CONFIRMATORY ANALYSIS:

ANO-2 Design Basis Accident Containment Response

U.S. Nuclear Regulatory Commission
Rockville, Maryland

August 2000

Fig. 3.2. Containment Pressure (LOCA Baseline Calculation).

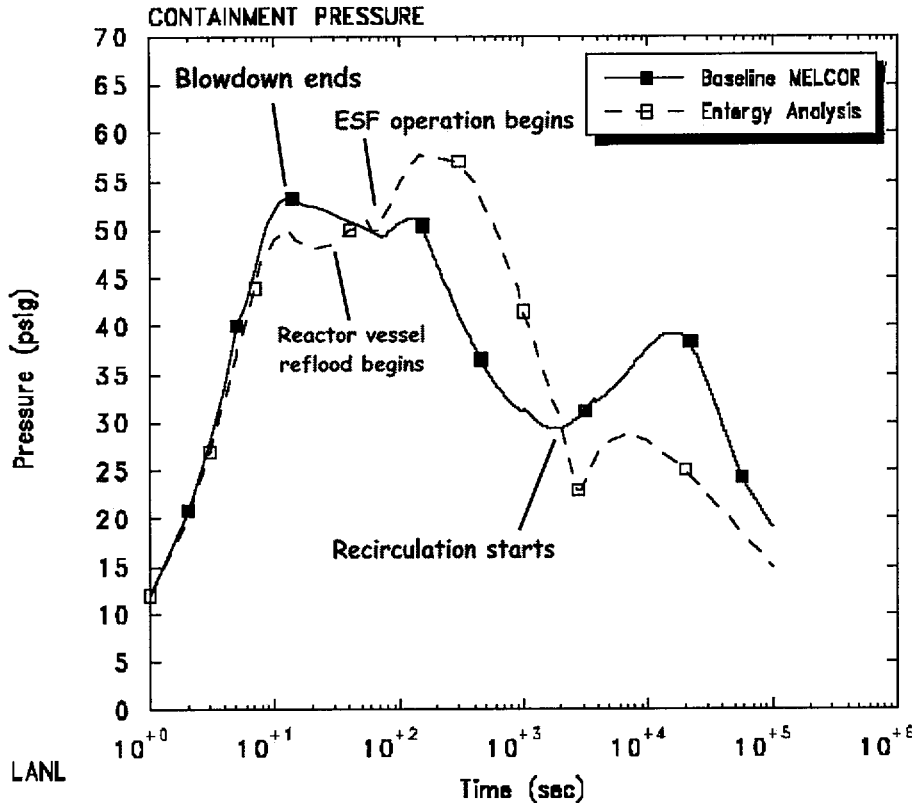
As indicated in Fig. 3.2, differences in calculated containment pressure signature following RCS blowdown lead to differences in the predicted peak pressure and the time at which it occurs. The qualitative trends in baseline confirmatory calculation and the licensee result are similar, but several quantitative details differ. The peak pressure immediately following RCS blowdown is approximately 5 psi higher in the MELCOR baseline calculation than the COPATTA result. More importantly, the subsequent rise in containment pressure resulting from mass/energy addition during reactor vessel reflood and from the residual energy released from RCS structures (refer to Fig. 2.1) is much smaller in the baseline calculation than in the licensee calculation. The peak pressures predicted in the two calculations are 57.7 psig (COPATTA) and 53.3 psig (MELCOR baseline). Potential causes for this difference are examined in the sensitivity calculations described in Sec. 3.1.2.

Fig. 3.3. Containment Temperature (LOCA Baseline Calculation).

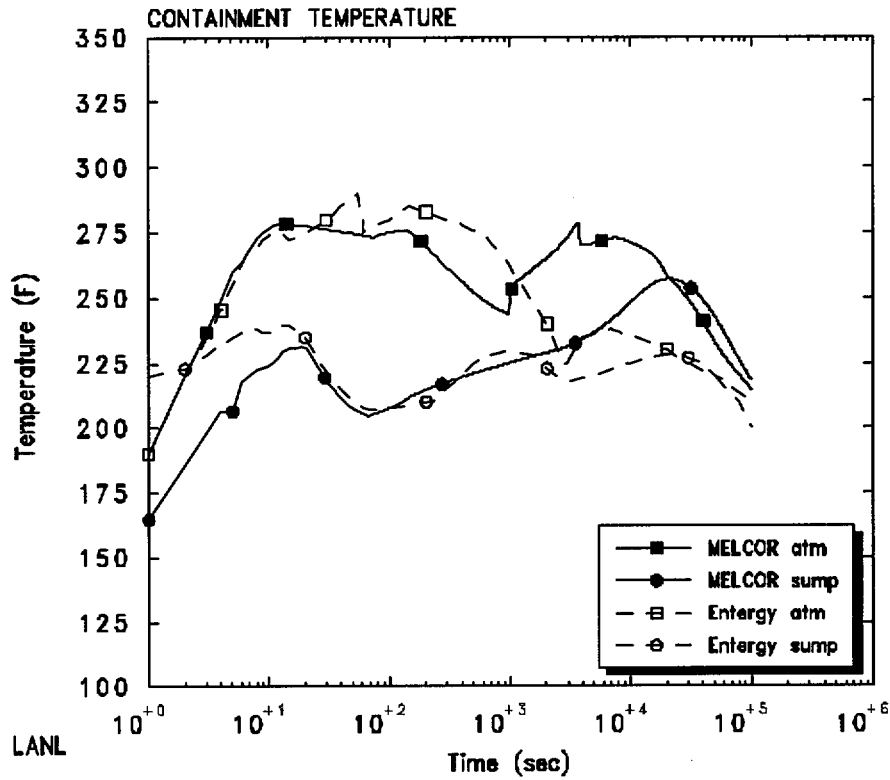
The containment temperature responses in the two calculations are compared in Fig. 3.3. Temperature signatures are shown for the containment atmosphere as well as for water in the sump. Again, the qualitative trends are very similar. Differences in the quantitative results, particularly peak temperature, are not as noteworthy as those for containment pressure. The peak temperature calculated in the MELCOR baseline analysis is 278.6 °F compared with 291°F in the licensee analysis.

Fig. 3.4. Containment Pressure (Sensitivity Cases 3, 4, and 5).

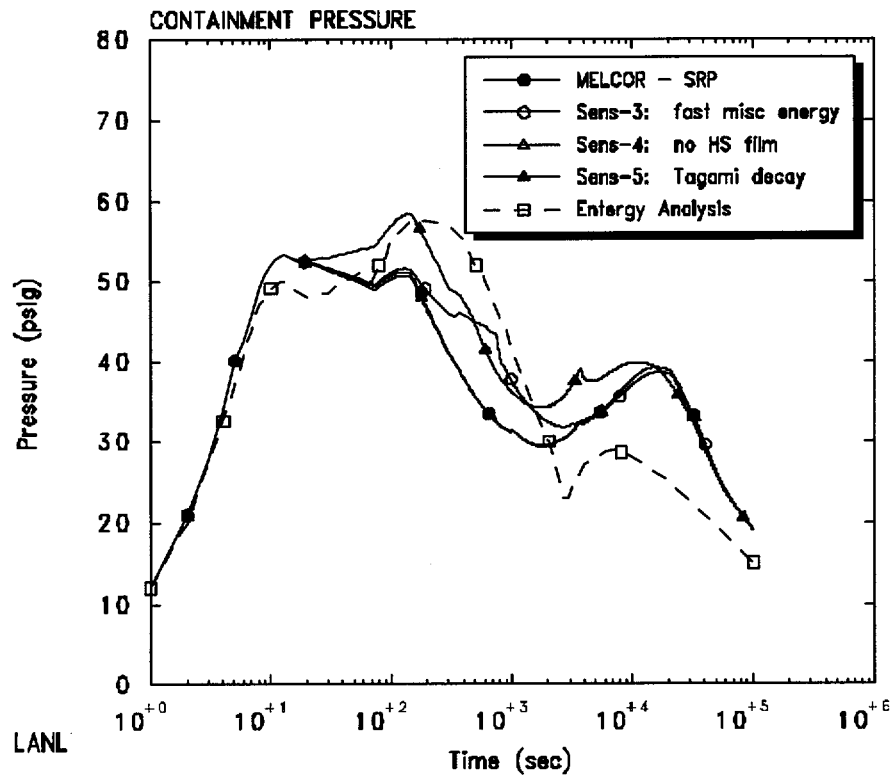
The containment pressure signatures generated in these three sensitivity calculations are compared with the MELCOR baseline and licensee results in Fig. 3.4.

The pressure signature for the case in which liquid films on the containment structures are neglected (i.e., condensate is transported to the sump immediately as it forms) is nearly identical to that for the baseline calculation. Changes in the other two parameters result in a noticeable change in the pressure history.

Accelerating the release of residual RCS energy is not shown to increase the peak pressure, but it slows the subsequent rate at which the containment depressurizes. Reducing the post-reflood containment structure surface coefficients generates a noticeable increase in peak pressure. The peak pressure for sensitivity case 5 is 58.4 psig, approximately 0.7 psi higher than the licensee result.

Fig. 3.5 Containment Temperature (Sensitivity Cases 3, 4, and 5).

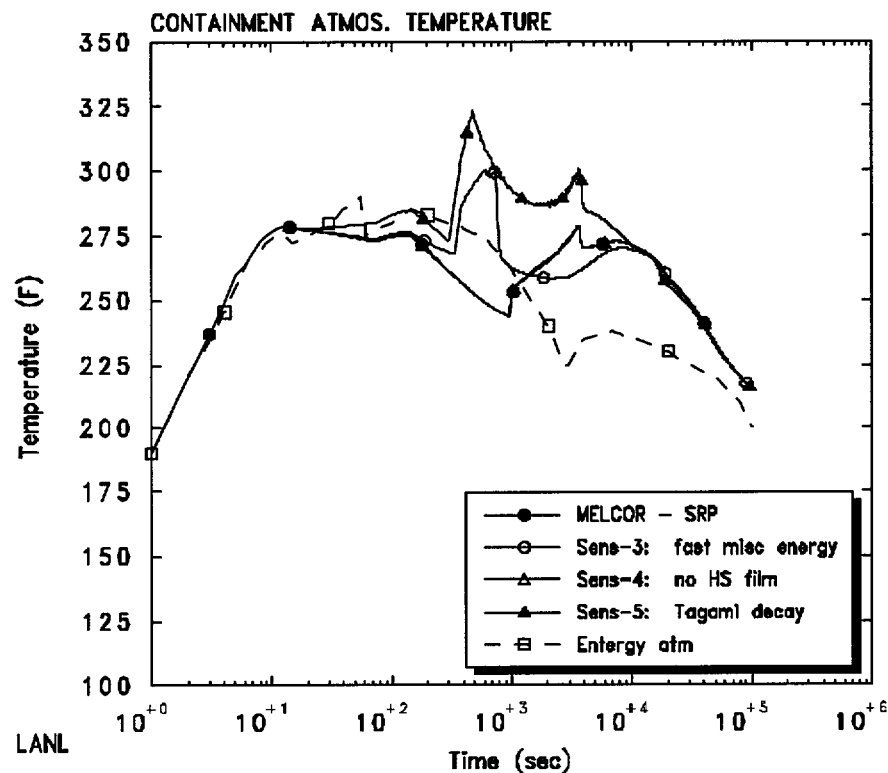
Sensitivity cases 3 and 5 also change the calculated peak containment temperature. As shown in Fig. 3.5, a sharp increase in temperature occurs in the two sensitivity calculations; this is caused by an imbalance between energy addition rates to the containment atmosphere and heat removal rates by ESF operation and structure surface heat transfer.

Fig. 3.6. Containment Pressure (Sensitivity Cases 1 and 2).

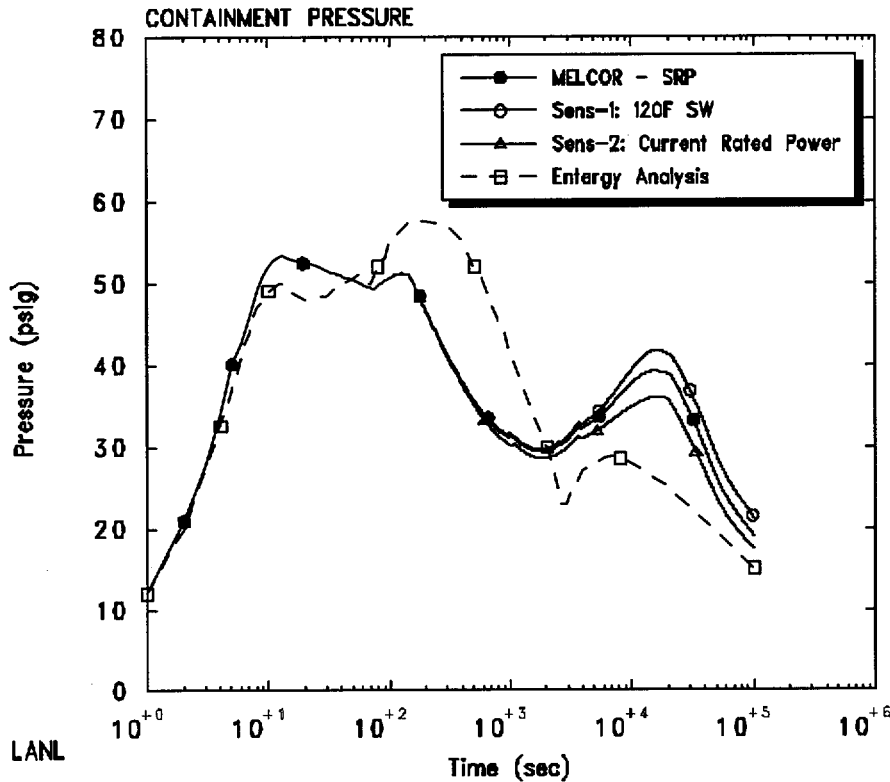
The results from these cases are shown in Fig. 3.6. Neither case significantly alters the calculated containment pressure signature before switchover to spray recirculation, but the secondary peak in pressure that occurs roughly 5 h (18,000 s) into the accident is reduced slightly at lower decay heat levels and is increased slightly with degraded air cooler performance.

Fig. 3.10. Containment Pressure (MSLB Baseline Calculation).

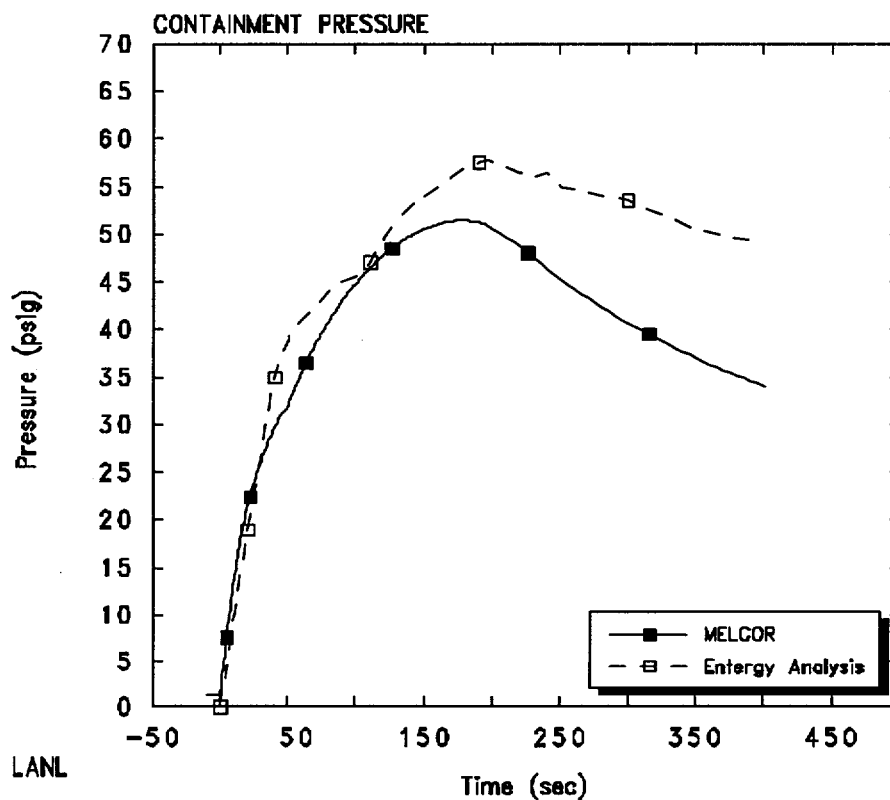
The calculated containment pressure response for the baseline MSLB analysis is shown in comparison with the licensee result in Fig. 3.10. As in the baseline LOCA calculation, the qualitative pressure

signatures are similar, but important quantitative differences are evident. First, the peak pressure in the MELCOR baseline calculation is significantly lower than the licensee result (50.0 vs 57.7 psig). The knee in the ascending pressure history is less evident in the MELCOR result than in the COPATTA result and occurs at a different time. The reasons for the difference in peak pressure are examined in the next section. The knee in the ascending pressure history occurs when superheat in the containment atmosphere is eliminated through operation of ESF systems. However, as indicated in Fig. 3.11, the amount of atmosphere superheat reflected in the MELCOR baseline calculation is ~120°F less than that in the COPATTA calculation. Consequently, the atmosphere returns to saturation conditions sooner in the MELCOR calculation; the knee is smaller and occurs earlier.

Altering the modeling assumptions associated with structure heat transfer as described below can eliminate these differences in results.

Fig. 3.12 Containment Pressure (MSLB Sensitivity Calculations).

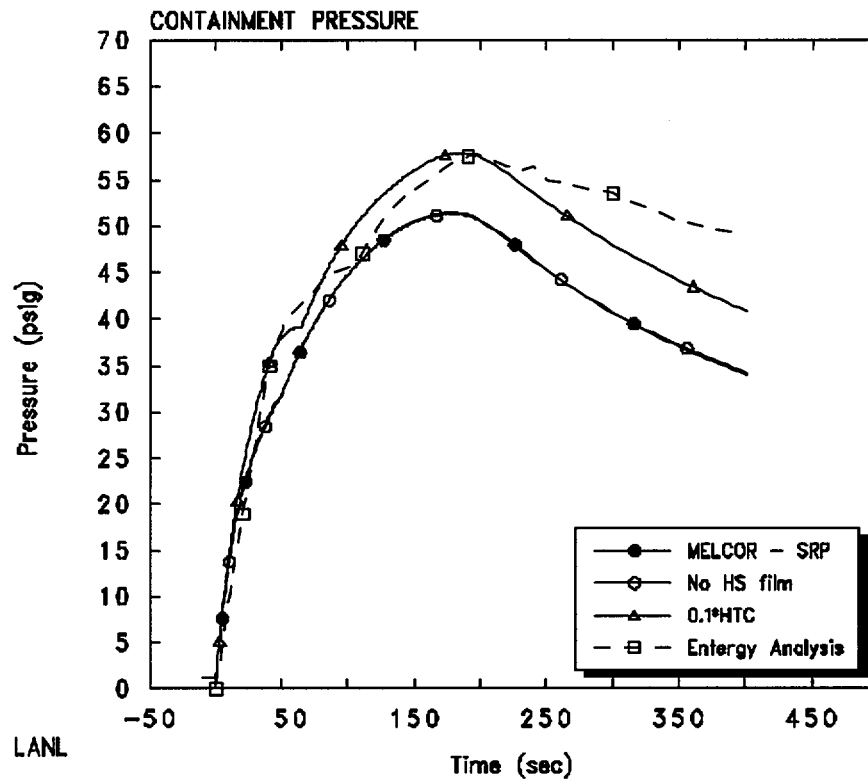
The resulting containment pressure signatures are shown in comparison with the baseline result and the licensee's result in Fig. 3.12. Ignoring the presence of condensate films on containment structures is shown to have no effect on the baseline results. However, the results of the second sensitivity case show excellent agreement with the licensee analysis. A similar improvement in the calculated atmosphere temperature response is shown in Fig. 3.13.

Fig. B-1. Containment Pressure—Original vs Revised Confirmatory Calculations.

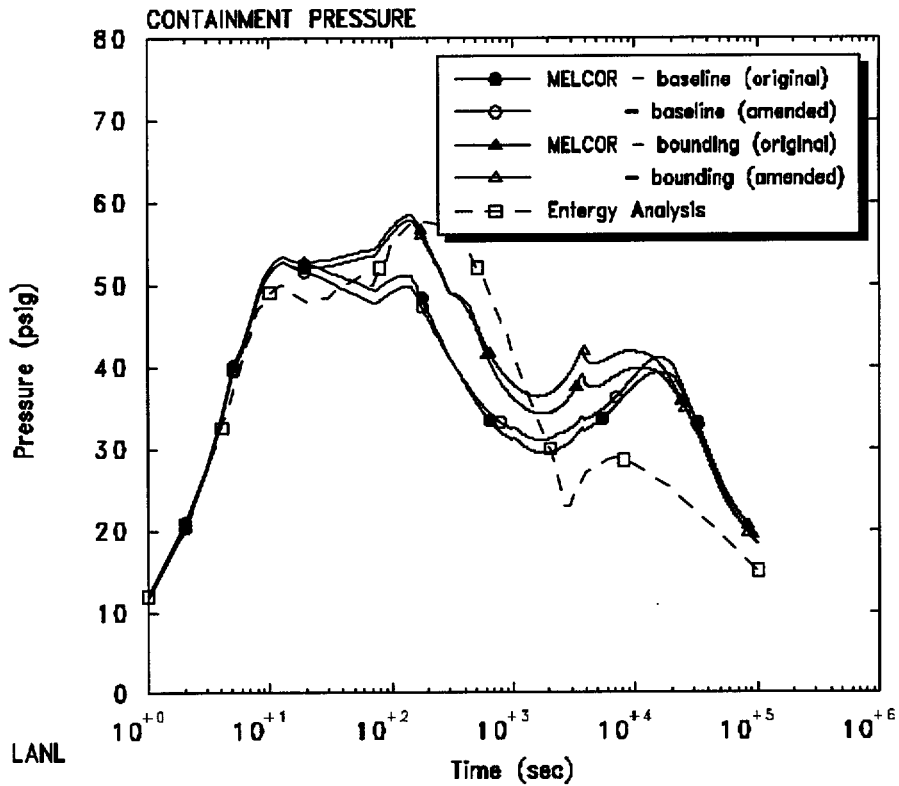
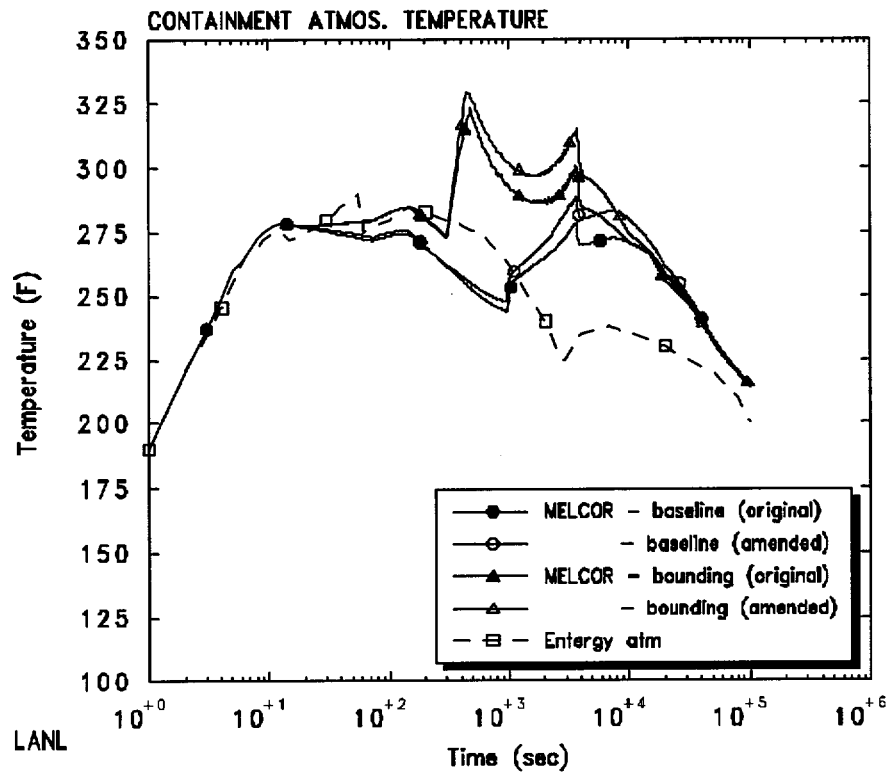
Revised confirmatory calculations were made for the LOCA baseline accident scenario as well as the scenario that generated the bounding containment pressure response (sensitivity case 5). Calculated containment pressure and temperature signatures are compared in Figs. B-1 and B-2, respectively.

The modifications made to the ANO-2 containment analysis described in the supplement to the licensee's Amendment Request do not alter key calculated results or conclusions drawn from the analysis described in the main body of this report.
